Kelsale cum Carlton [KcC] is one of the largest (by area) Parishes in the Suffolk Coastal area and comprises a combined Parish of two village entities (Kelsale and Carlton), three historic Greens (Curlew, North and East) and is bisected by the A12, with the bulk of residents living to the east of it.

KcCPC's response to EDF Energy's Stage 3 Volume 1	– Section 1 Introduction	4-7
	– Section 2 Project Overview	8-15
	– Section 3 Planning Context	16-19
	– Section 4 Socio-economics	20-39
	– Section 5 Transport Strategy	40-67
	– Section 6 Traffic Modelling	68-94
	– Section 7 Main Development Site	95-114
	– Section 8 Rail	115-120
	– Section 9 Level Crossings	121-128
	– Section 10 Sizewell Link Road	129-150
	– Section 11 Theberton Bypass	151-156
	– Section 12 Two Village Bypass	157-161
	– Section 13 Northern Park and Ride	162-165
	– Section 14 Southern Park and Ride	166-170
	– Section 15 Freight Management Facilities	171-176
	– Section 16 Yoxford Roundabout	177-179
	– Section 17 Highway Improvements, Cycling & PRoW	180-187

**Table 6.4 Peak period of Sizewell C construction – changes in HGV and bus flows (typical day) at the locations identified in Figure 6.6**

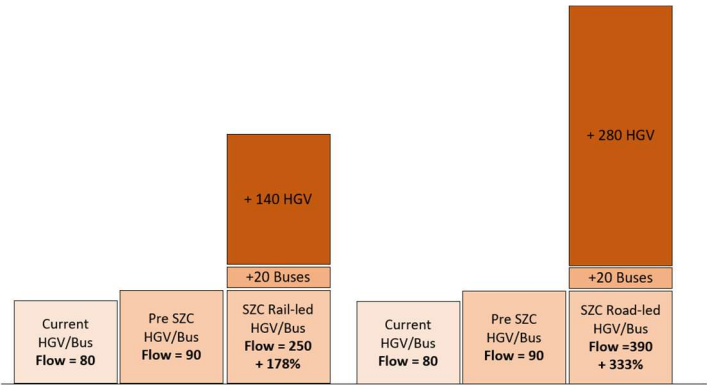
Why not:

**Note:** The same error shown at Line 1 in Table 6.4 is repeated in Table 6.5 and many numbers appear broadly similar.

Figure 1

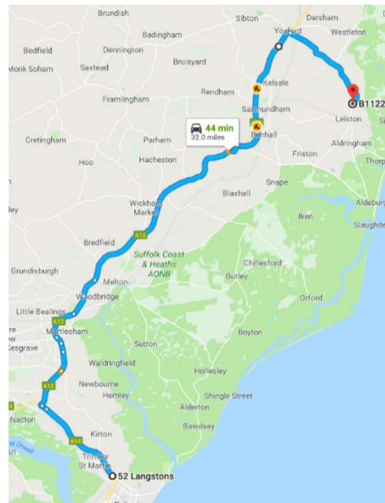
KcCPC is absolutely clear that the Sizewell Link proposal coming forward from EDF Energy at Stage 3 is totally unacceptable. It is not thought through, puts valuable, good quality agricultural land under tarmac, destroys wildlife habitats, only to complete the encircling of the communities that, EDF Energy claim to be helping.

Moreover, it comes at the end of a tortuous 30-mile journey (Figure 1), from either of proposed Freight Management Facilities, on or adjacent to the A14 east of the A12 junction.

The soundness of any proposal to take such an enormous HGV burden, so far north, for such a protracted period of time has to be called into question when considered alone, but fold in the other considerations and the absurdity becomes self-evident. KcCPC will explore some of the other considerations in due course.
